**From:** DeFrank, Andrew (DDOT) <Andrew.Defrank@dc.gov>  
**Sent:** Monday, April 5, 2021 2:56 PM  
**To:** Gove, Amber (SMD 6A04) <6A04@anc.dc.gov>  
**Subject:** Update to March 2019 list

14th Street and G Street NE

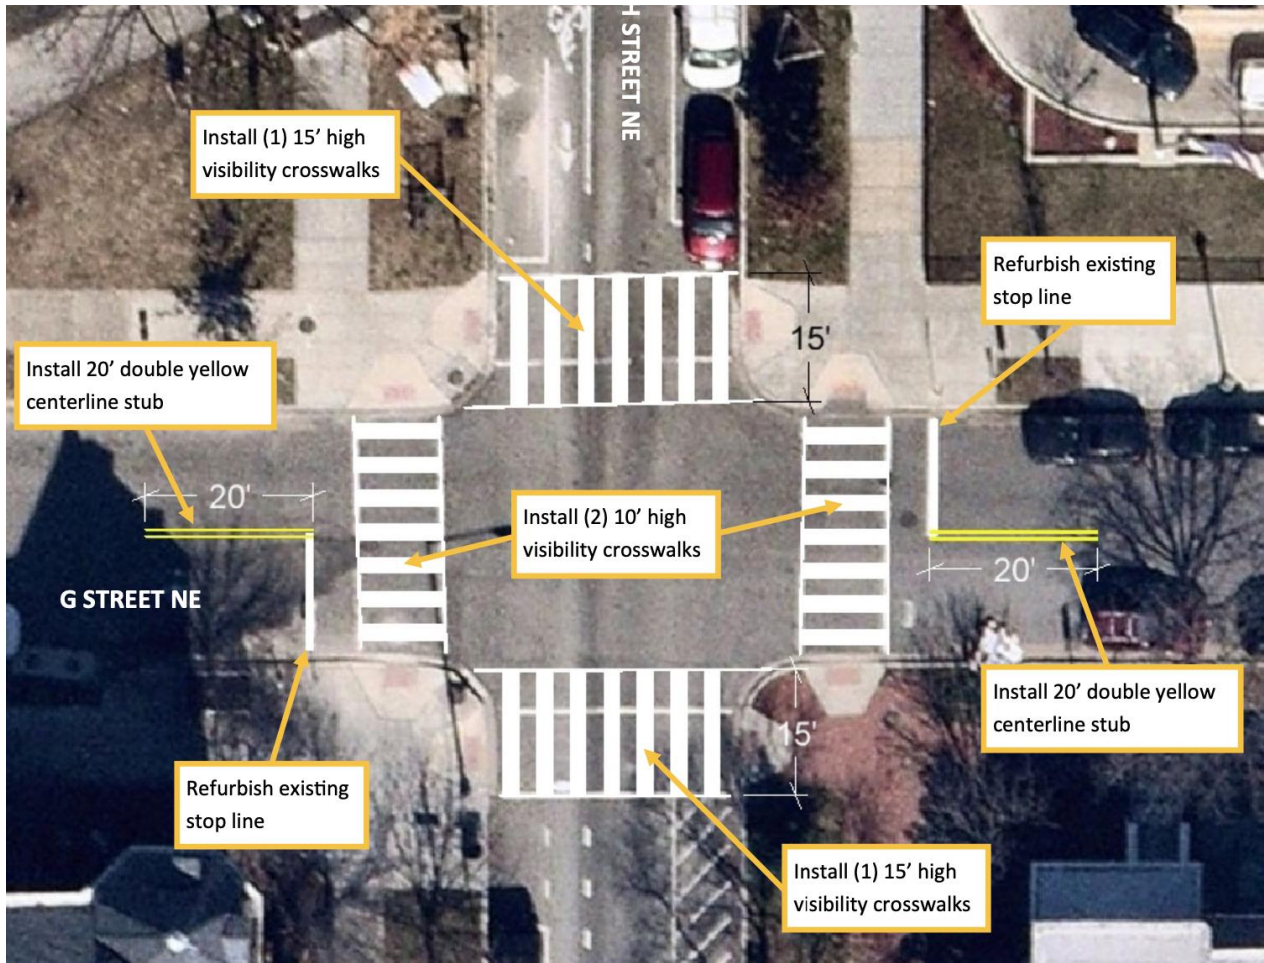
11. Intersection at 14th and G Sts. NE. Chick-Fil-A-related traffic makes wrong-way turn north onto 14th St. as a shortcut. Possibly bulb-out or pylons would make this less tempting.

*March 2021: This will be installed under WO 972068 (markings), 972069 (signage). See attached.*

**INSTALL:**

- (1) STOP (R1-1 30"x30") signs
- (2) DO NOT ENTER (R5-1 30"x30") sign
- (3) ONE WAY (R6-1aL 36"x12") signs (left arrow)
- (3) ONE WAY (R6-1aR 36"x12") signs (right arrow)
- (1) No Left Turn (R3-2 24"x24") sign
- (1) No Right Turn (R3-1 24"x24") sign
- (3) u-beams

**REMOVE:**

- (1) STOP sign
- (1) DO NOT ENTER sign
- (2) ONE WAY signs
- (4) u-beams
